ŀ	(S	SC ENVIRONMEN	NTAL CH	ECKLIST		
1. PROJECT TITLE:				2. PROJECT NO.:		
Starfighters Fuel Tank				KCA-4244		
3. PROJECT LOCATION: 🕱 K	SC	☐ CCAFS ☐ PAFB	4. FACILITY NAM	IE/NO.:		
☐ OTHER			J6-2313 Landing	Aids Control Bldg

Jet Fuel Storage Facility

09-0156 Rev A (K6-E1108692)

Subject: RE: Site Plan Review Request for Site Plan 09-0156 WON E1108692 - Jet Fuel Storage

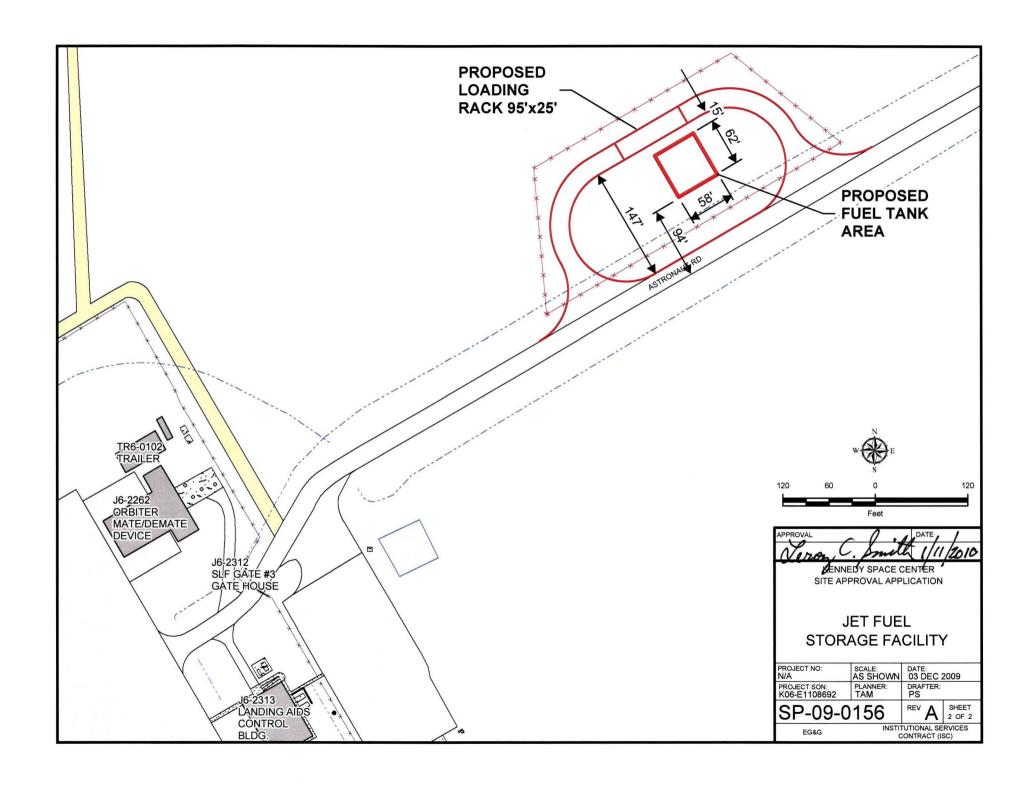
A revised KSC Environmental Checklist must be submitted to the Environmental Management Branch (TA-B1C).

A stormwater permit from St. Johns River Water Management District will be required. Permit application, drawings, calculations, etc. should be submitted to Doug Durham, TA-B1B. Contact Doug at 867-8429 for additional information.

The tank(s) must be registered with the Brevard County Natural Resources Management Office. The County requires a 30 day installation notification. Call Doug Younger (867-4556) for tank registration requirements.

This site is adjacent to wetlands, and there may be restrictions, permitting and mitigation requirements associated with using the proposed area.

Request explanation of the validity of the fuel volume requirements, originally it was one 30K gal tank. Also request a detailed description of the secondary containment system to be utilized for these tanks since they are single-walled construction; it would be best to have double-walled tanks with interstitial monitoring to avoid inherent rainwater issues. Provide this information to Doug Tomlin (TA-B1B, 867-3659).

Tenant must ensure that they have a Spill Prevention, Control, and Countermeasures (SPCC) Plan of their own in place before operation per 40 CFR 112 and of course comply with all the requirements of the SPCC Rule. The proposed tank(s) must be incorporated into the KSC SPCC Plan. Contact Doug Tomlin (867-3659) for clarification of SPCC rules.

Tenant must ensure they obtain any required Clean Air Act Permits through the FDEP for their operations that produce any air pollutant emission sources as well as comply with all the requirements of the Clean Air Act.
